Work Order ID 108679

Item Name: Crosstube Turning Detail

DART AEROSPACE LTD	Work Order:	108679
Description: Crosstube Assembly (412 High Aft)	Part Number:	D412-664-243
Inspection Dwg: D412-664-243 Rev: E		Page 1 of 2

DRAWING NO. D412-664-243	TITLE CROSSTUBE ASS'Y (412 HI AFT)	REV. E	DART AEROSPACE LTD ENGINEERING ORDER		D.E.O. NO. D412-664-243-E-2	SHEET NO. SHEET 1 OF 1	SCALE NTS
DRAWN 92	CHECKED ASS	MFG. APPR. E	APPROVED MP		DE APPR. H		
DATE 11.09.07	DATE 11.09.19	DATE 11.09.19	DATE 11.09.19		DATE 11.09.19

**D412-664-243
ASSEMBLY DETAIL**

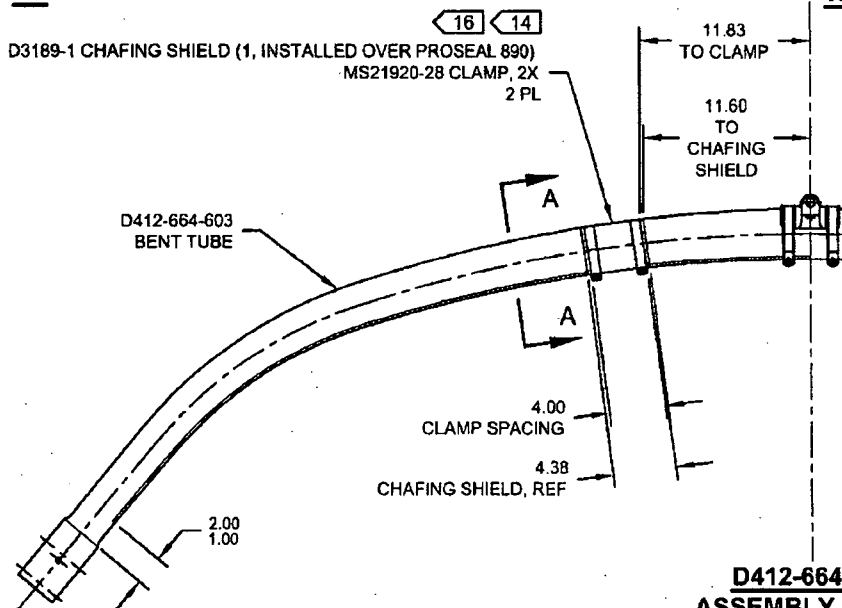
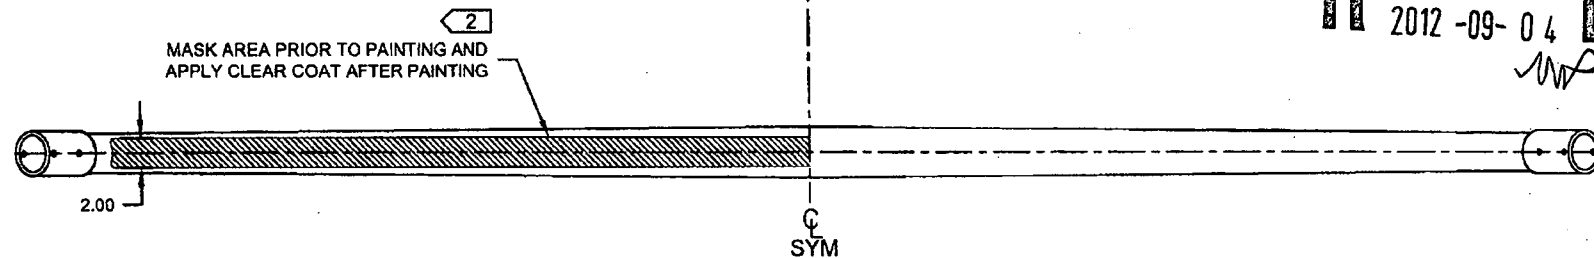
REMOVED ABRASION STRIP IN FAVOR OF A THIN LAYER OF PROSEAL 890. UPDATE INSTALLATION OF CHAFING SHIELDS AND REDUCE TORQUE TO 40-50 IN-LBS. THIS ENGINEERING ORDER SUPERCEDES DEO D412-664-243-E-1.

D3189-1 CHAFING SHIELD (1, INSTALLED OVER PROSEAL 890)
MS21920-28 CLAMP, 2X
2 PL

D2856-600-1009 ABRASION STRIP
D3189-1 CHAFING SHIELD (1, INSTALLED OVER ABRASION STRIP)
MS21920-28 CLAMP, 2X
2 PL
